# Access Compliance Report

## Public Rights-of-Way

Intersection ID: 10037286	Main Street: SARDIS_RD_NORTH	Cross Street: N/A	Location: SW
ADA ID: 321454E93A52	Ramp Type: Para	Initial Pass/Fail: Fail	Overall Compliance: No
		Severity Score: 1.25

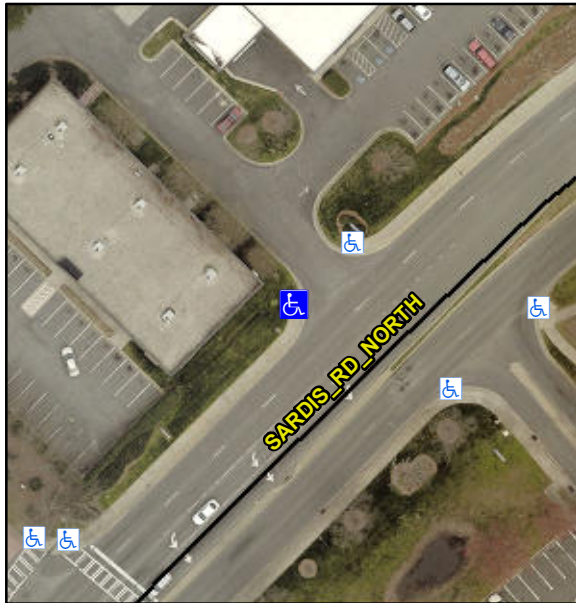
**RT RP < 5%**

**Not Found, R304.5.3**

**Remove & Replace Entire Ramp.**
